1607 Chinley Community Centre (HPK/2021/0525)

Discharge of Conditions no. 11

Details of Sustainable Surface Water Drainage Scheme

Proposed Drainage Plan

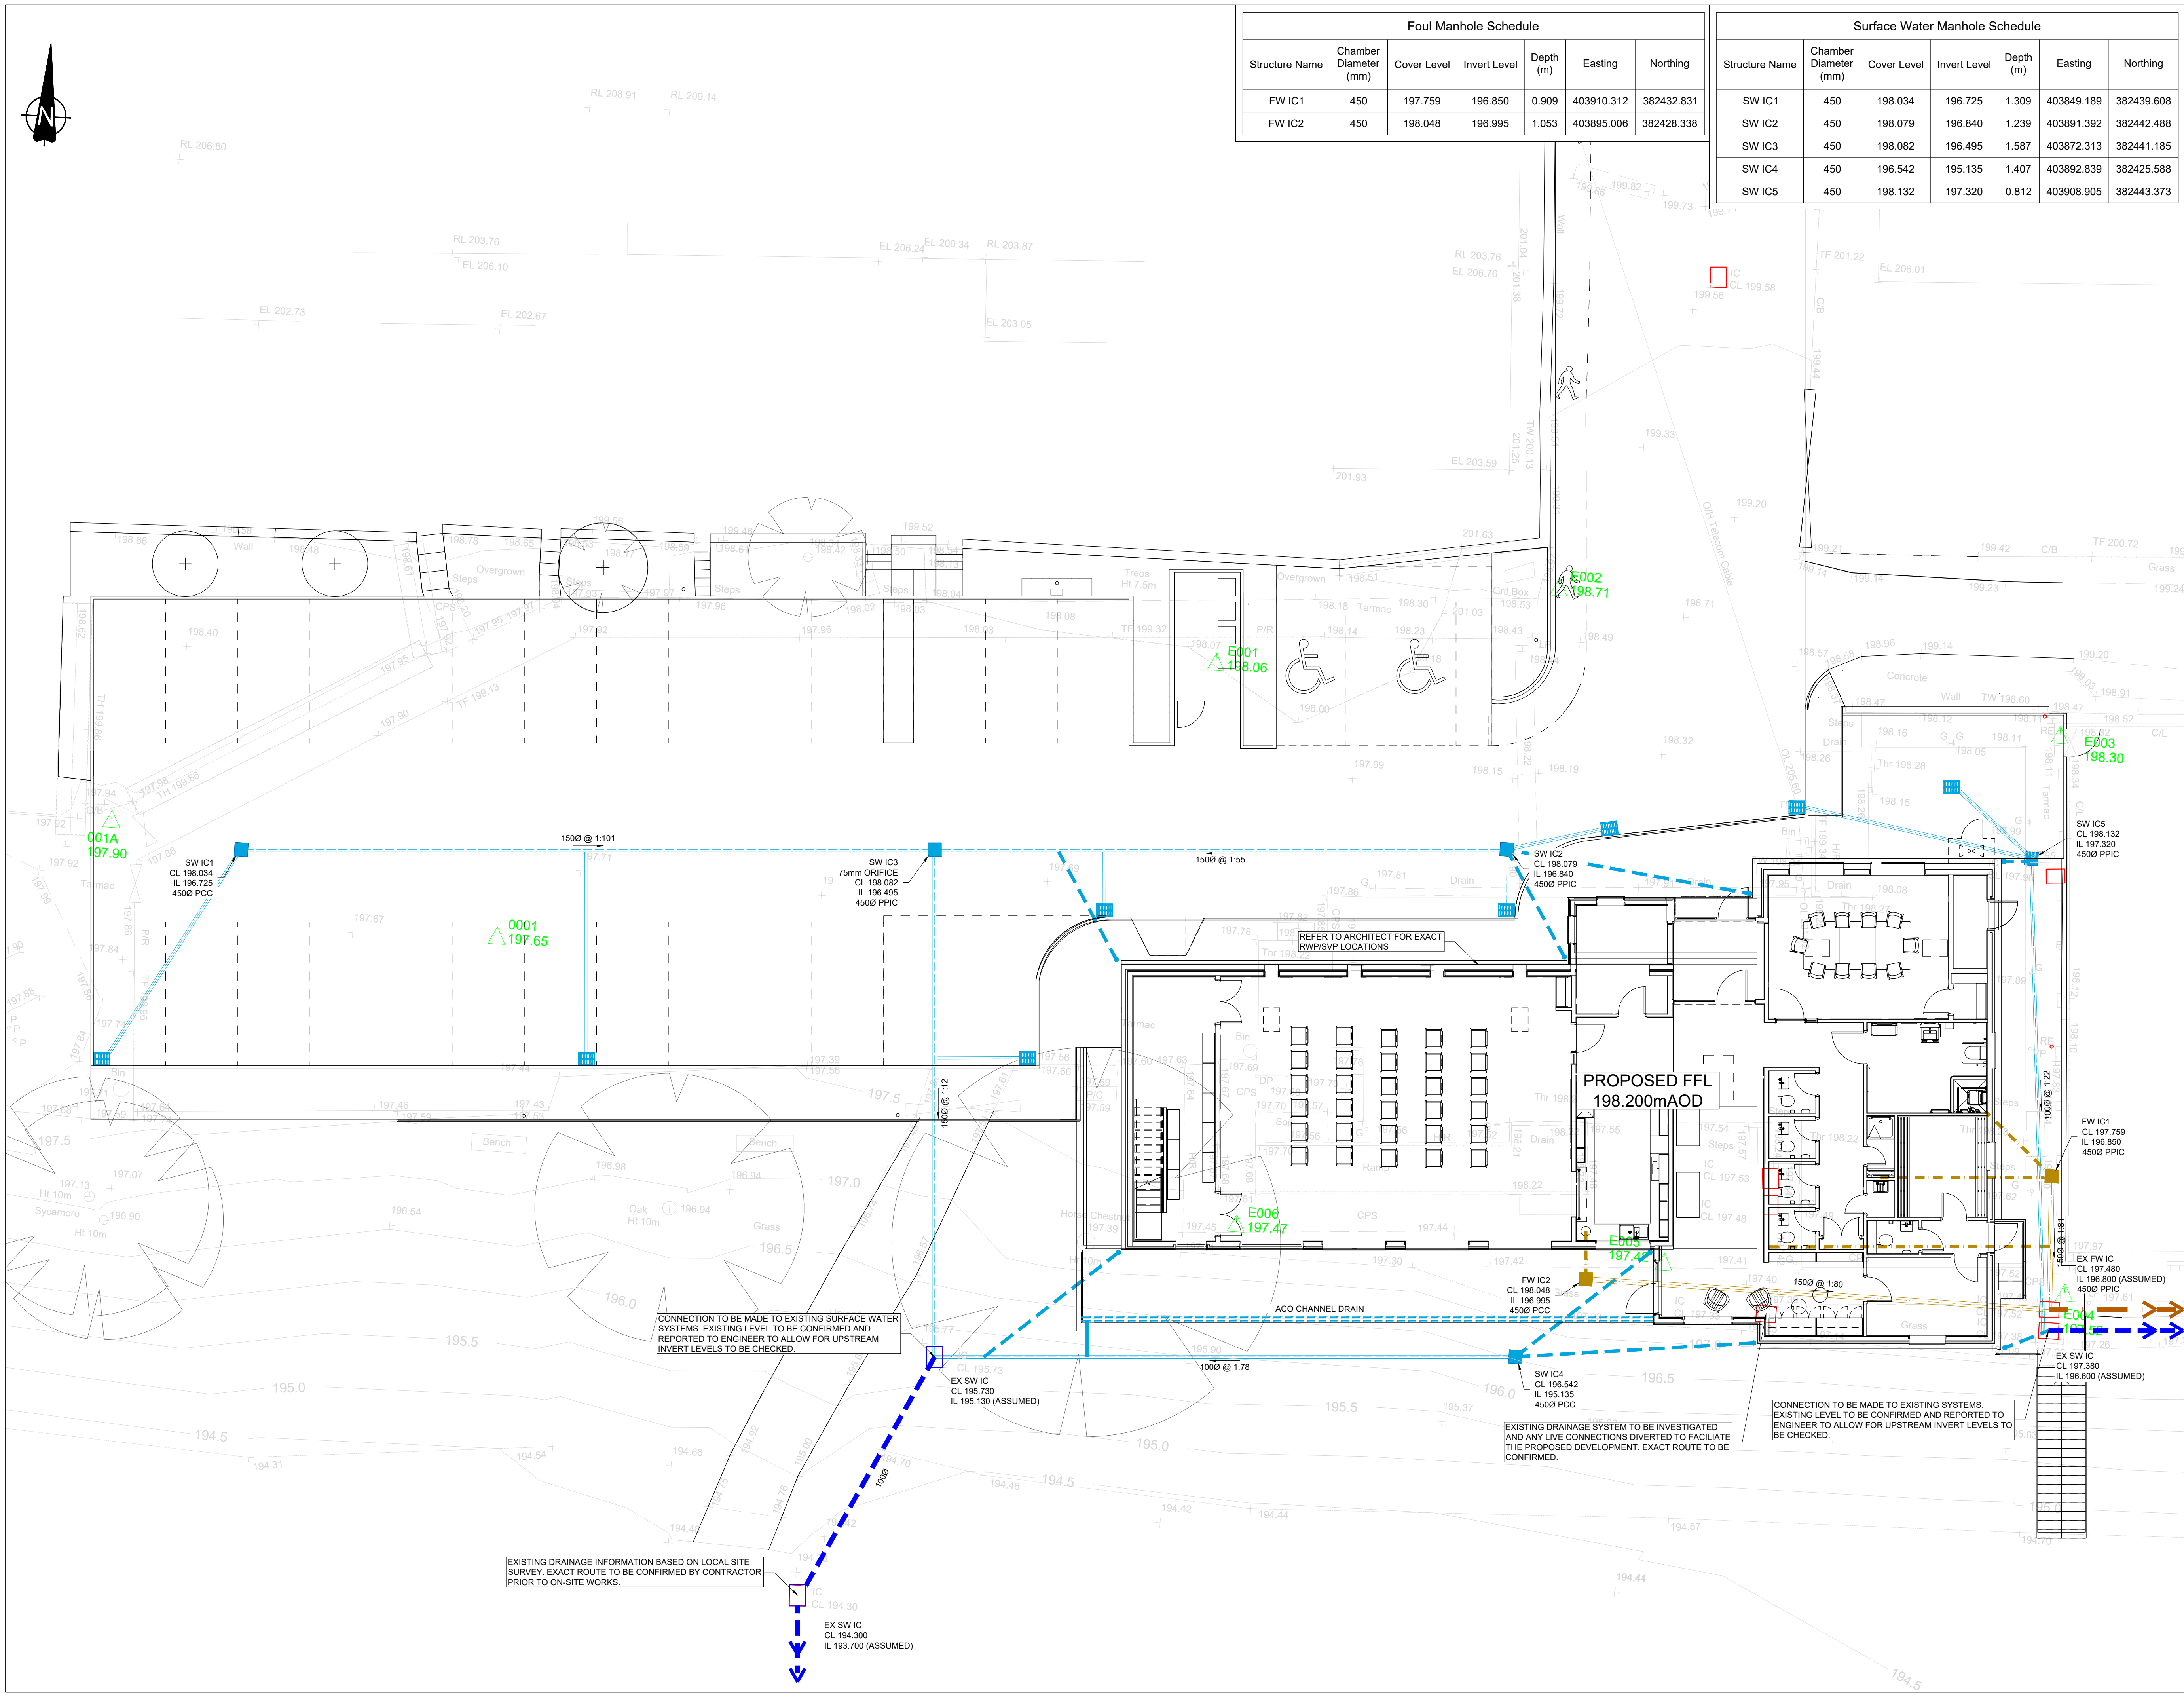
11. Sustainable surface water drainage scheme:

- i) A site investigation was undertaken by Ensaf Consultants which concluded that superficial deposits of Glacial Till was encountered beneath the Made Ground in all locations. This stratum typically comprised firm to stiff dark brown slightly gravelly CLAY. This precludes the use of infiltration drainage systems for the development, discharge to a watercourse via a surface water sewer was considered the favourable option in accordance with the drainage hierarchy.

- ii) Discharge from the site has been restricted by a 75mm orifice plate which has been sized in accordance with best practice guidelines for minimum orifice diameter.

- iii) Proposed drainage drawing attached with all level information in mAOD.
- iv) FFL has been set 150mm above external ground levels and external ground levels have been designed to safely route overland flows away from buildings, using the less vulnerable parts of the proposed development to convey and attenuate / store overland flows. Overland flows resulting from exceedance events are expected to leave the developed site towards the low-lying south-west portion of the site, as currently occurs, without posing any increased flood risk on site or elsewhere.

- v) CCTV Survey report attached—surface water (SW) discharges to ditch/watercourse and foul water (FW) connects to existing manhole. Both immediately West of garage block behind No.2 Rhuddlan Place.

- vi) Noted, design has been prepared as such.
